Re: CPO: Blanchardstown Bus Corridor, Case Reference: KA29N.313961

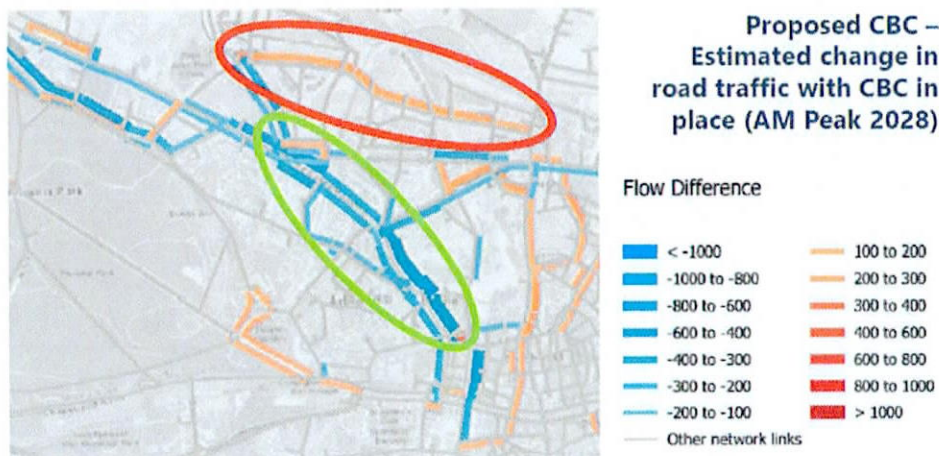
There are three road restriction changes proposed in the CPO application for the Blanchardstown Bus Corridor, none of which were set out in any of the proposed designs issued for public consultation since the Bus Connects project commenced in 2018.

The final preferred route was the result of three separate and rigorous stages of consultation since 2018 and yet none of the three proposed restrictions appeared in the [final preferred route](#) publication dated March 2022.

A number of changes were negotiated at a local level with residents' groups, in particular **Annamoe Road and Annamoe Terrace** (ref. B1) residents and their efforts to ensure their road does not become a "rat run," arising from the displaced traffic from the Old Cabra Road has meant significant changes to the original proposal which has dire consequences for our area. It is not clear why one resident's group would be successful in their endeavours to engage with the NTA to the severe detriment of another area such as mine.

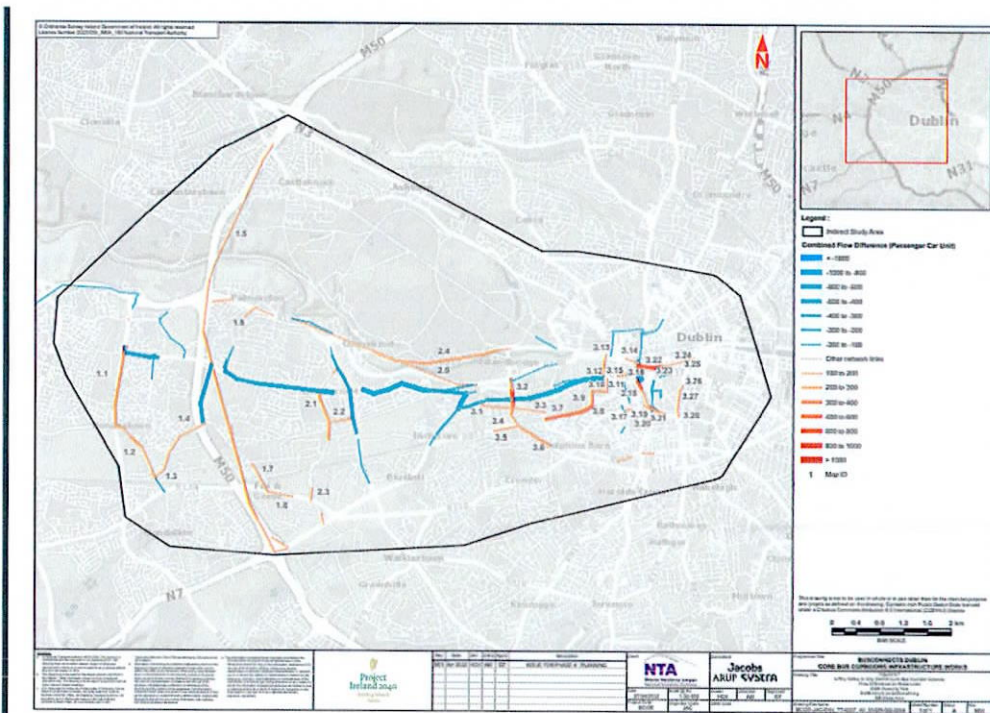
- **Flawed classification system of the impacts which sees areas forecast to experience an 80% increase in traffic flows being described as a “low impact” change.** In appendix A6.4 of the EIAR, Impact Assessments, the following are estimated when comparing a “Do Minimum” with a “Do Something” (i.e., BusConnects) scenario at PM peak hour:
 - An 80% increase in hourly traffic flows at the junction of Connaught Street and Shandon Crescent,
 - A 55% increase in hourly traffic flows at the junction of Fassaugh Ave and Dingle Road,
 - A 64% increase in hourly traffic flows at the junction of Fassaugh Ave and Bannow Road.

Each is described as having “not significant” effect and “negligible” impact. I can tell you as a resident of Connaught Street there is no way that changes of this nature can be considered “not significant” and “negligible” in their impacts on our abilities to go about our daily lives and live in a safe environment!

Furthermore, there is an estimated 70% increase in peak hourly traffic flows at the junction of Connaught Street and St Peter’s Road. This was described as being a “low impact” with “moderate”

effect. It appears that only areas that are forecast to experience increases in traffic volume to beyond 85% of road capacity are classified as having any impact at all.
